# MORGAN OFFSHORE WIND PROJECT: GENERATION ASSETS

## Annex 3.2 to the Applicant's response to Harbour Energy's submission at Deadline 5

Application Reference: EN010136

Document Number: MRCNS-J3303-RPS-10240

Figure A.1: Millom East Buffer Zones.

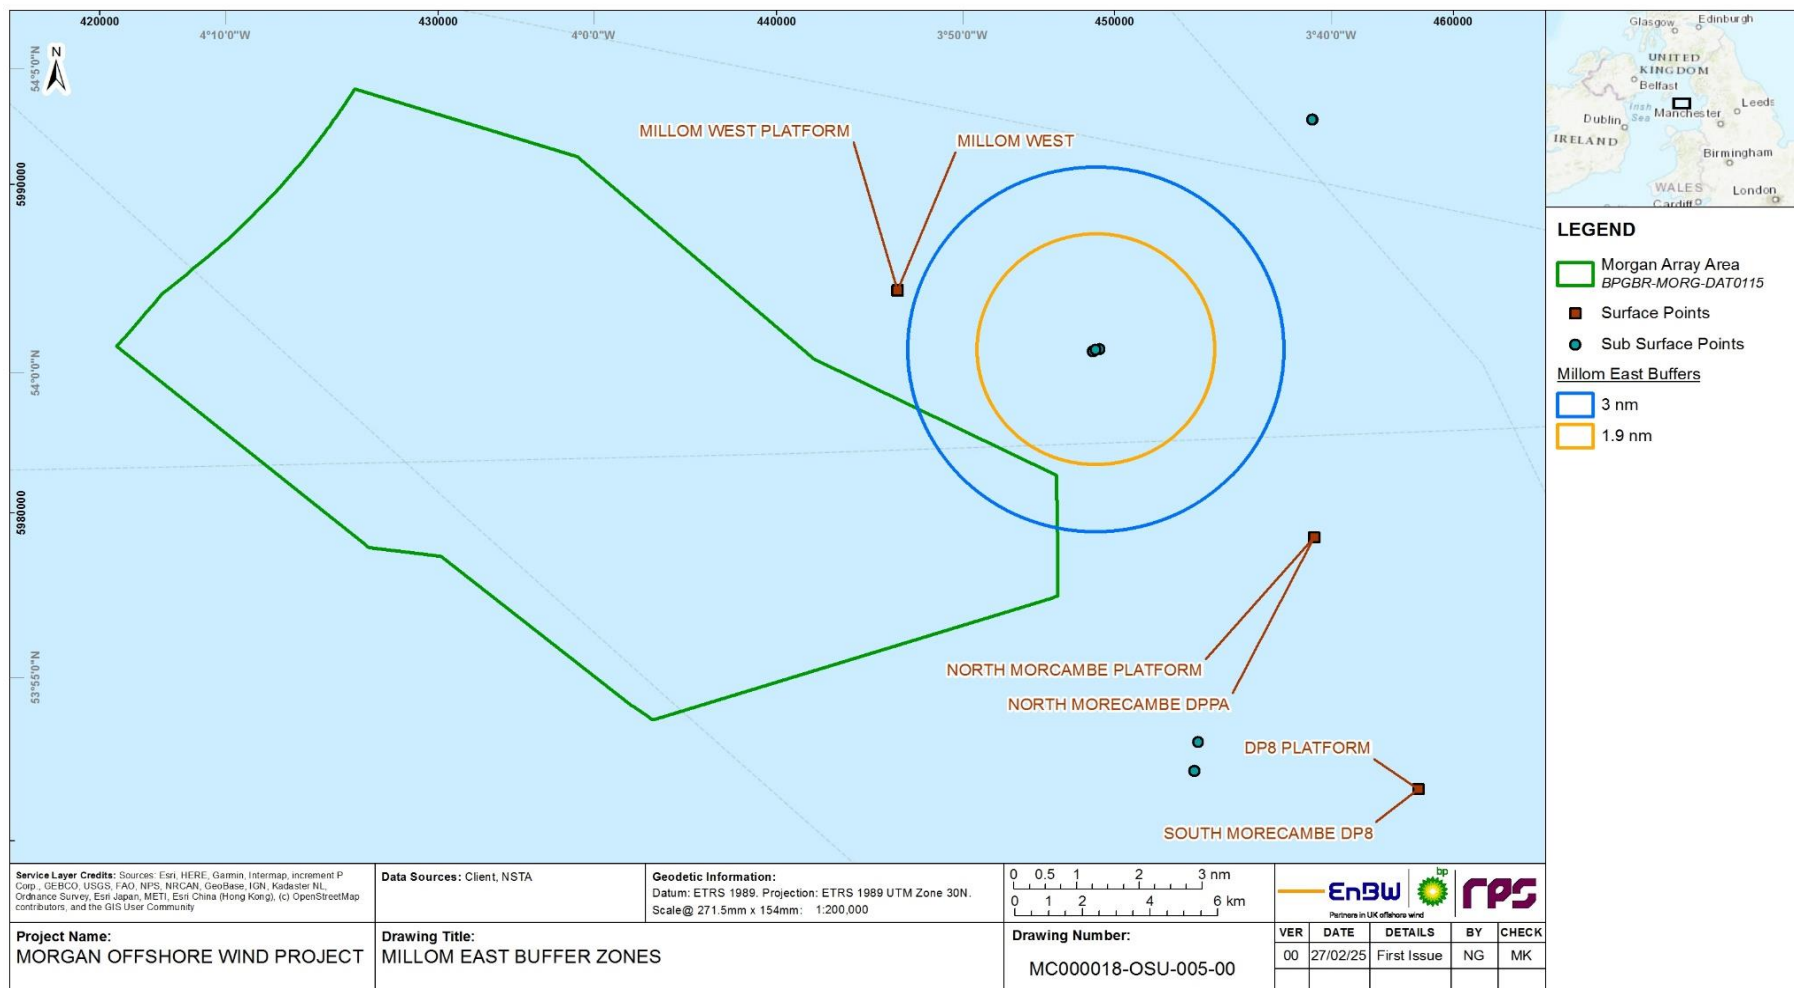
REP5-054.9 REP5-064a.9	<p><b>3. Potential Mitigations</b></p> <p><b>3.1. 3nm exclusion zone</b></p> <p>A potential mitigation to the disruption and economic loss arising from the impact of the Morgan Generation Assets was proposed in Section 2.2.2.1 of Harbour Energy's Written Representation (REP1-045) – namely that no wind turbine generators be placed with any part thereof (including rotor tips) within 3nm of the Millom East pipeline end manifold (PLEM). It should be noted that this would still result in a loss of 4% of currently available opportunities to fly to an NPI at Millom East as instrument take-off would still be affected.</p>	<p>Harbour Energy's Written Representation (REP1-044, Appendix 1 A1.2.6) claims that an obstacle free radius of 1.9 nm is required around a helideck. In REP5-054.9 they further request an obstacle free distance of 3 nm around the Millom East PLEM (Pipeline End Manifold). Based on current practice and recent DCOs, a distance of 3 nm or 1.9 nm is excessive (see Figure A.1) and not supported by current Commercial Air Transport (CAT) operations in and around wind farms. Figure A.1 shows these distances in relation to the Morgan Generation Assets.</p> <p>For example, Protective Provisions were included in the Hornsea Four Offshore Wind Farm Order 2023 for the Johnston Wellheads<sup>2</sup>, situated inside the Hornsea Project Four Offshore Wind Farm. Helicopter access to a NPI during the decommissioning of the Johnston Wellheads will be required. Access to Millom East is a similar case, where short term helicopter access is required to a NPI helideck during decommissioning. In the case of the Johnston Wellhead, the Protective Provisions for the benefit of Harbour Energy secured:</p> <ul style="list-style-type: none"> <li>• an aviation corridor 1,400 m (0.76 nm) wide, measured tip to tip from any wind turbine generator</li> <li>• a wind turbine exclusion zone of 1,600 m (0.86 nm) radius of clear airspace measured from the centre of each of the Johnston production wellheads.</li> </ul> <p>The aviation corridor will enable helicopter access to the wellhead areas. The wind turbine exclusion zone around each wellhead will provide sufficient space for an approach and take-off. Both the Johnston and Millom East helicopter operations will be conducted under the same CAT Regulations.</p> <p>These distances are also consistent with other day VMC operations to helidecks located inside, or adjacent to offshore wind farms. An NPI has been working both adjacent to and within offshore wind farms in both the North and Irish Sea including within the nearby Walney Extension site where NPI's have been working at the Whitehaven and Rhyl wells inside the wind farm with turbines located between 1.1 and 1.3 nm from the NPI.</p>
